October 31, 1985
ST-HL-AE-1439
File No.: G9.17

South Texas Project
Units 1 and 2
Docket Nos. STN 50-498, STN 50-499
Responses to DSER/FSAR Items
On Chapter 6

Question 440.40N

Figure 6.3.1 Amendment 51

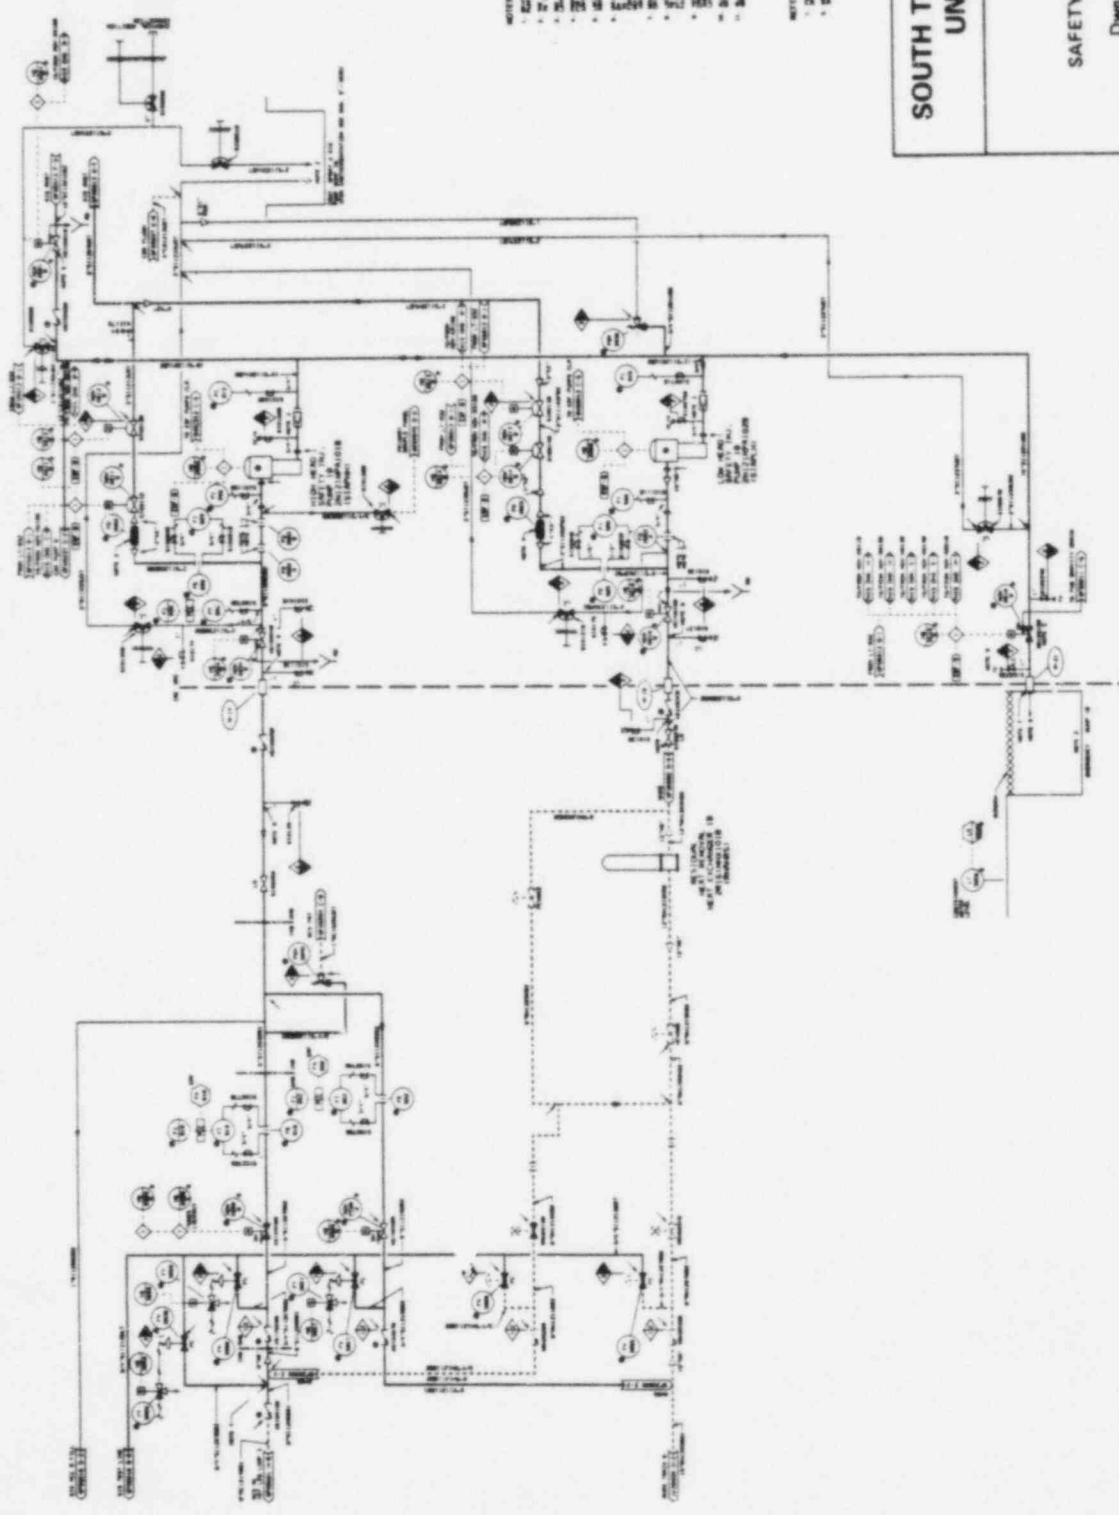
The SI Jockey Pump System has been deleted (Section 6.3 ~~will be~~ ^{has been} revised).

~~The LHSI subsystem is maintained in a filled condition by a jockey pump system.~~
